# 33 Cross Street

OVERLOOKING STUDY

FEBRUARY 2025

ASSESSMENT  
NORTH RESIDENTIAL TERRACES

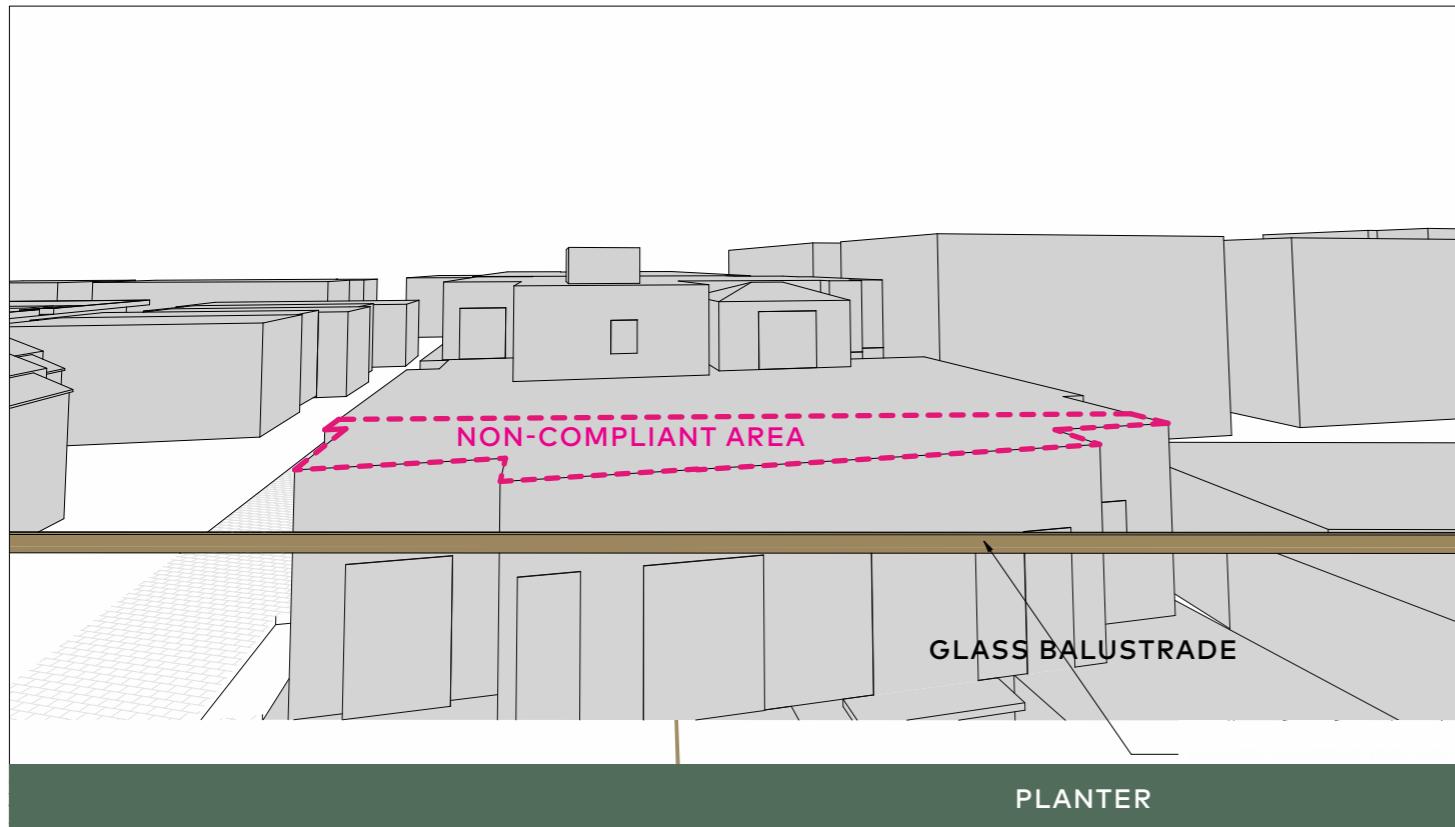
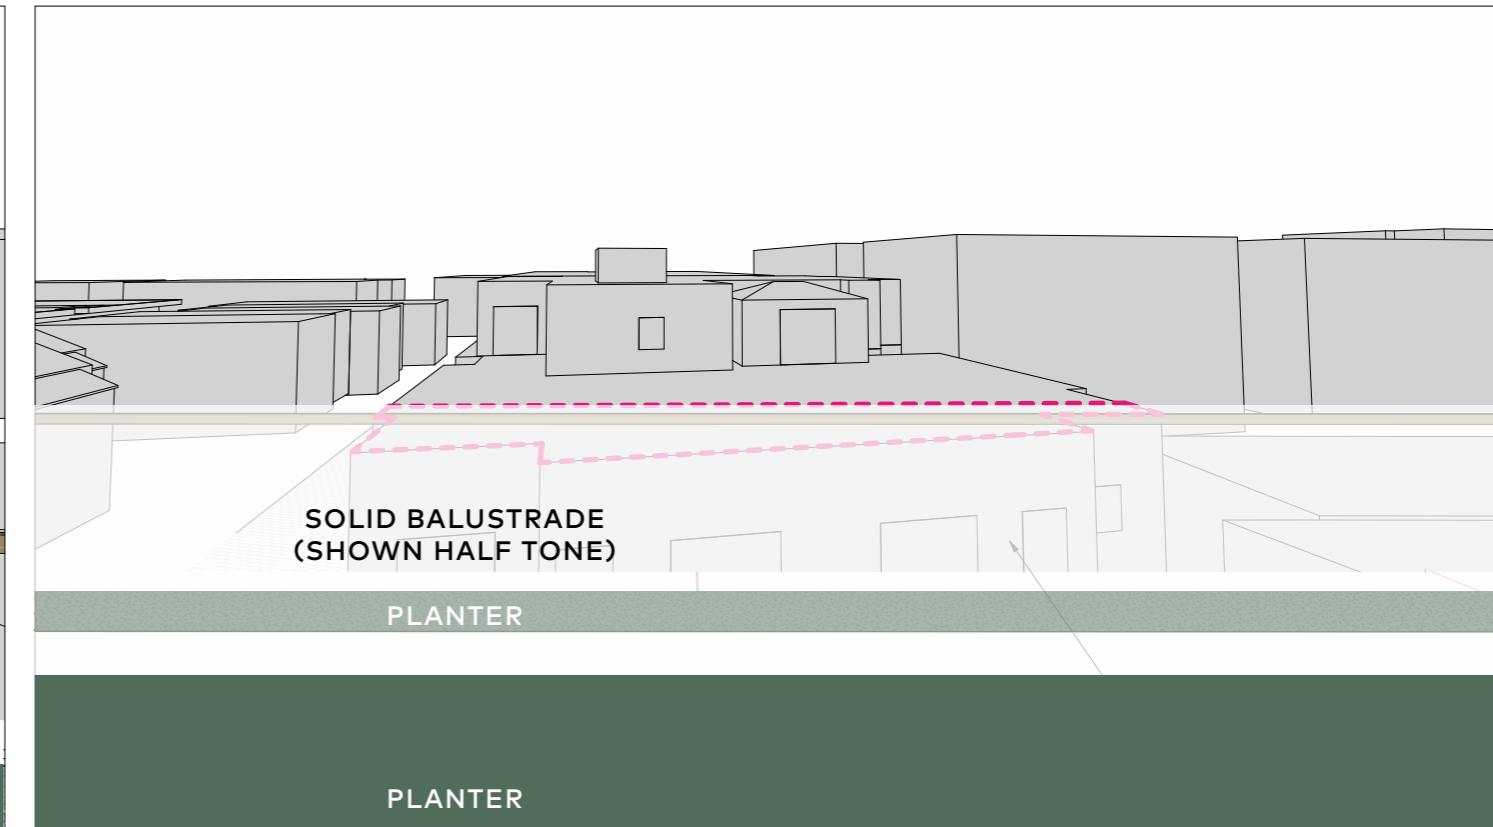
PUSH PLANTER BACK 800MM, CHANGE  
BALUSTRADE TO SOLID, BALCONY DEPTH 3M

## ASSESSMENT LEVEL TWO - EAST

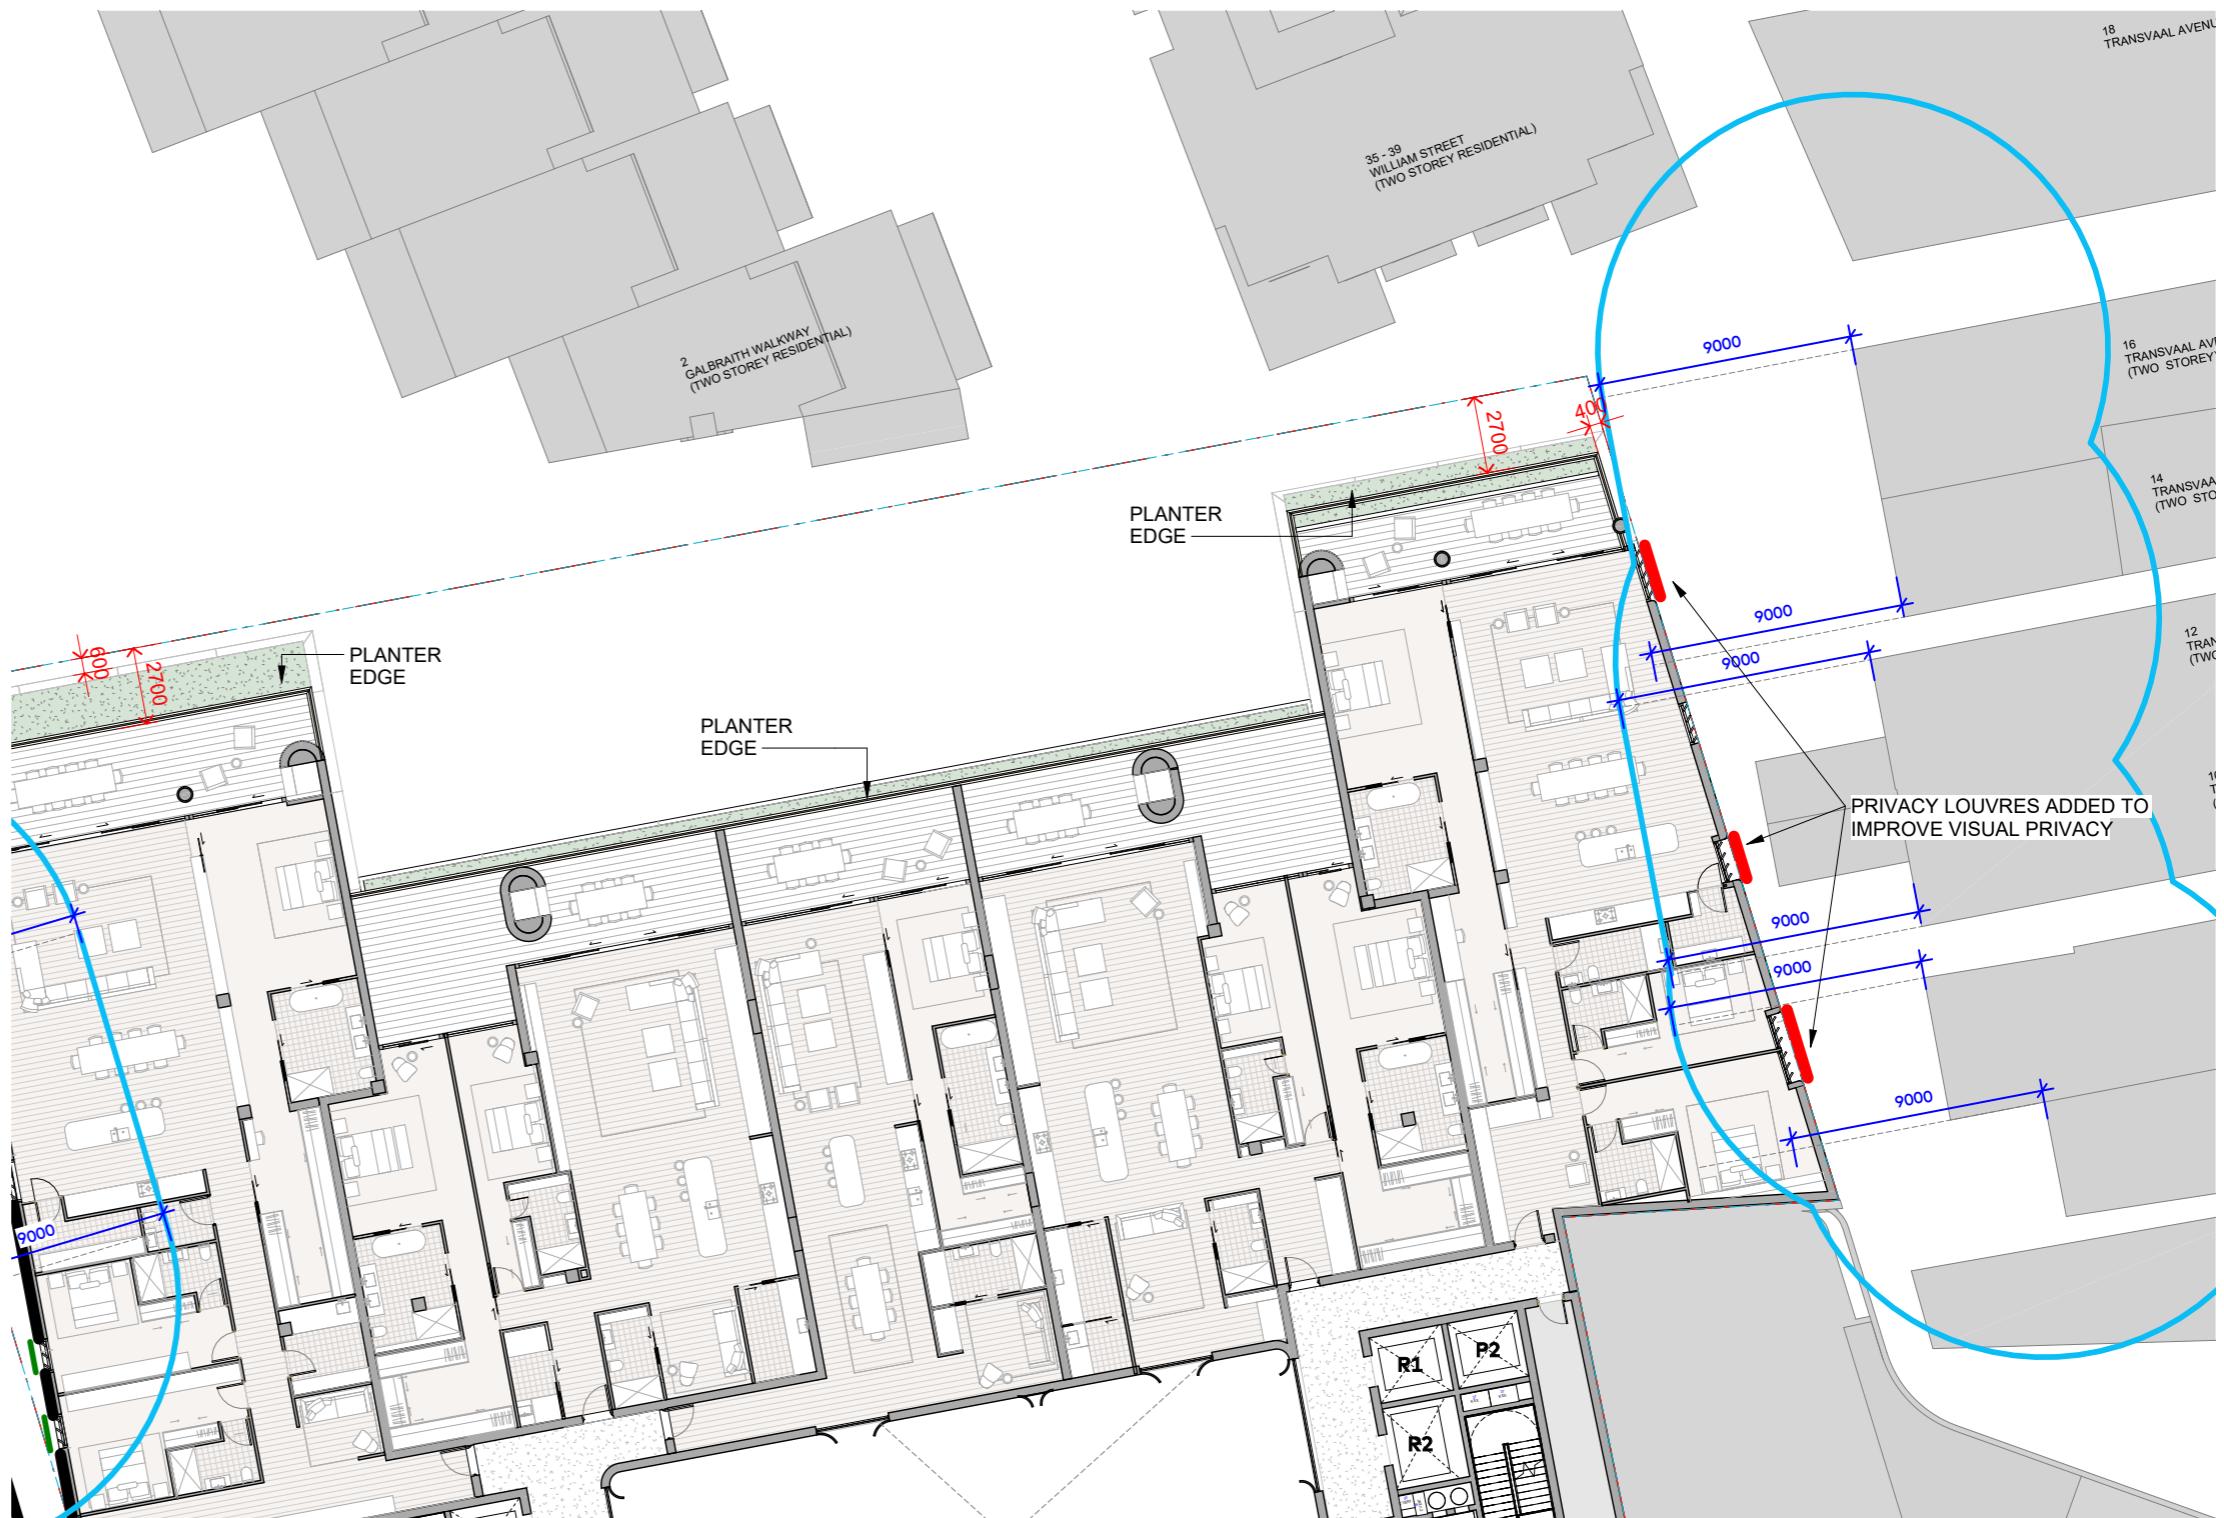
9M BETWEEN OUR WINDOWS

AND NEIGHBOURING  
TERRACES/WINDOWS

**GSA HAS CONFIRMED THAT LOUVRED WINDOWS TO RESIDENTIAL  
EASTERN FACADE CAN COMPLY**

## EAST FACADE

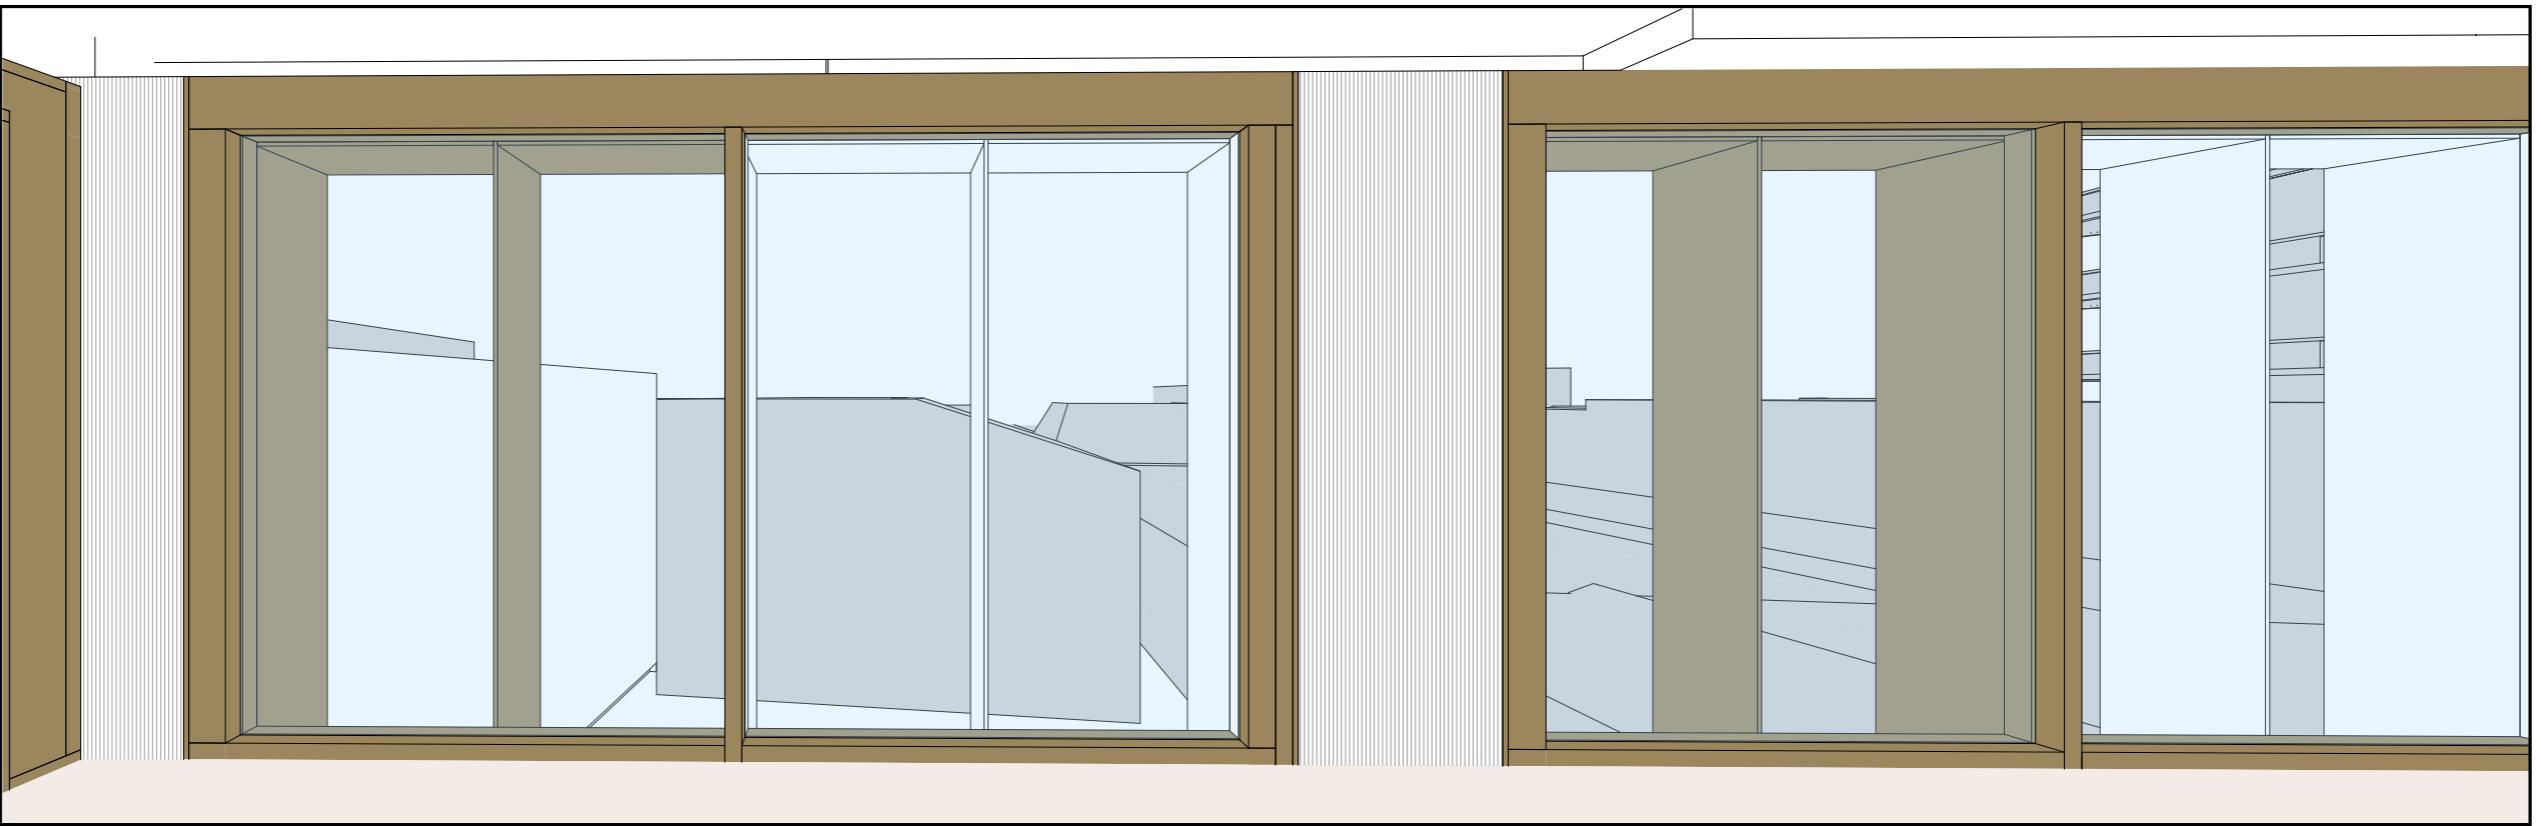
### ARCHITECTURAL DESIGN SOLUTIONS STILL TO BE RESOLVED FOR EASTERN COMMERCIAL FAÇADE

EG. BLADES, OBSCURED GLASS ETC.

### BRONZE BLADES

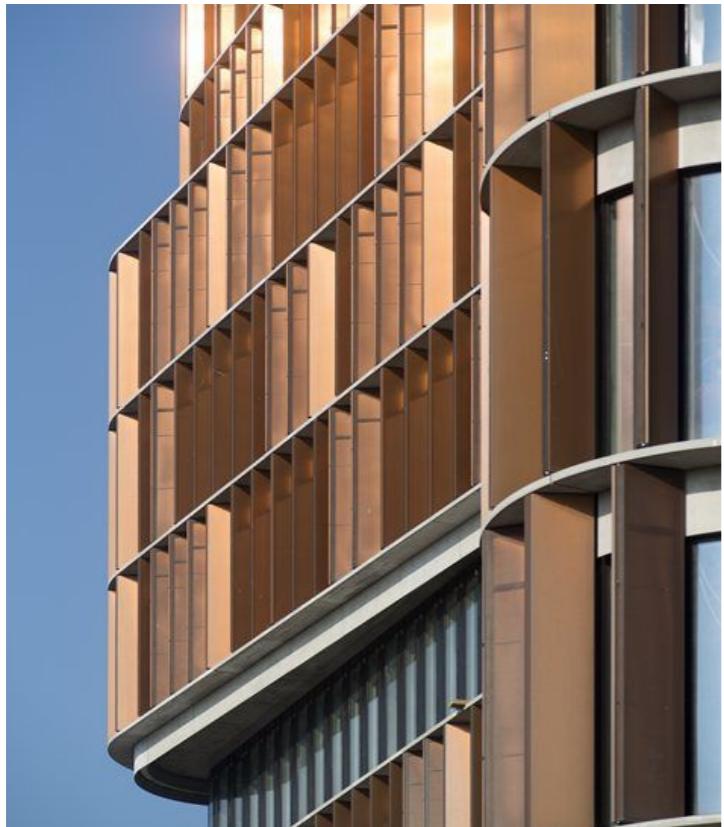
GOOD OVERLOOKING MITIGATION  
PROVEN WITH WOOLLAHRA  
ALLOWS DIRECT SUNLIGHT/SHADING

### OBSCURED GLASS

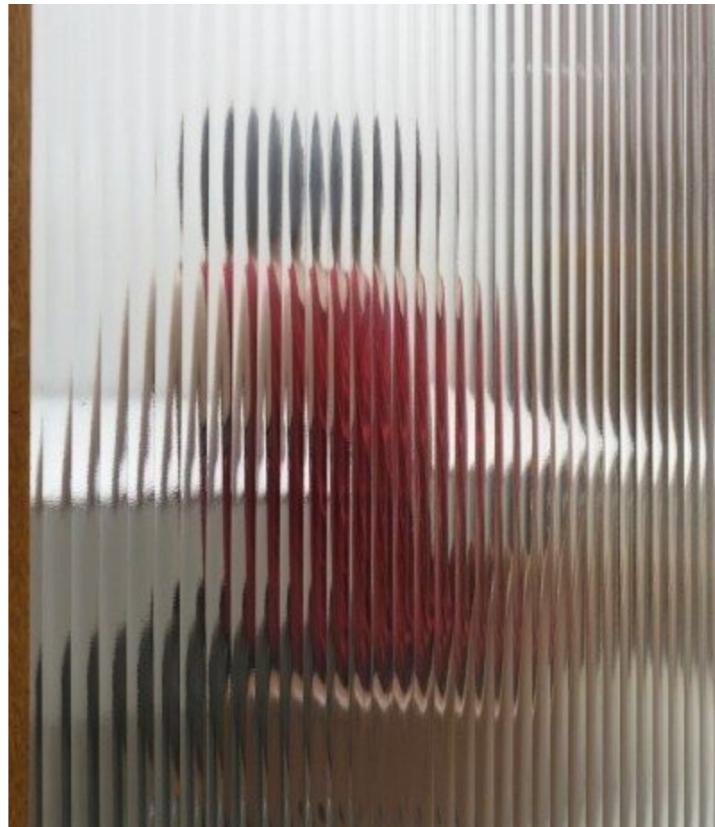
GOOD OVERLOOKING MITIGATION  
ALLOWS DIRECT SUNLIGHT  
NO SHADING

### LAMINATED MESH FACADE

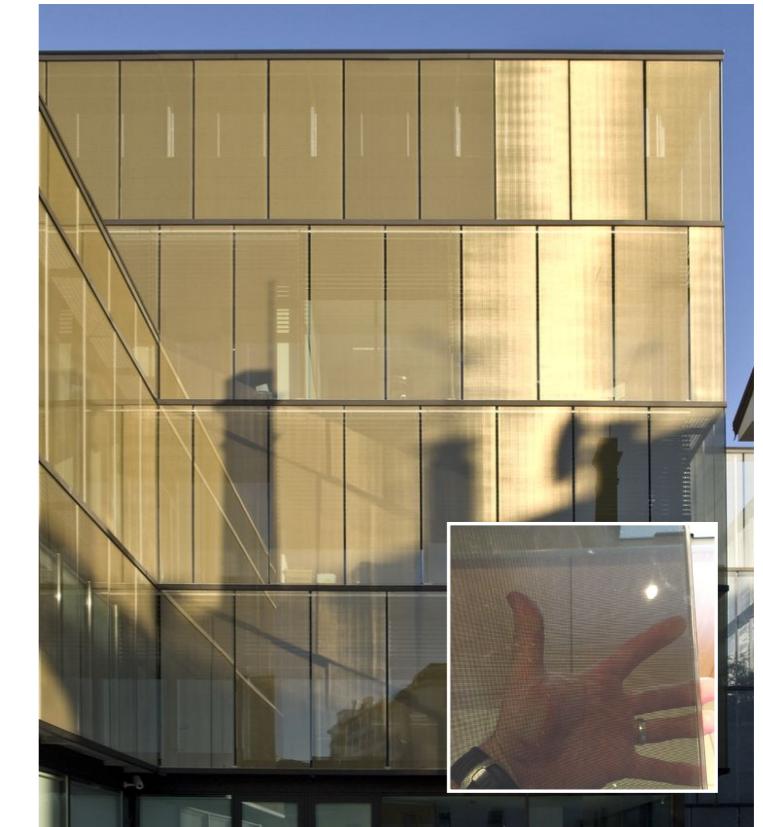
LITTLE OVERLOOKING MITIGATION  
GOOD PRIVACY MITIGATION  
GOOD SHADING
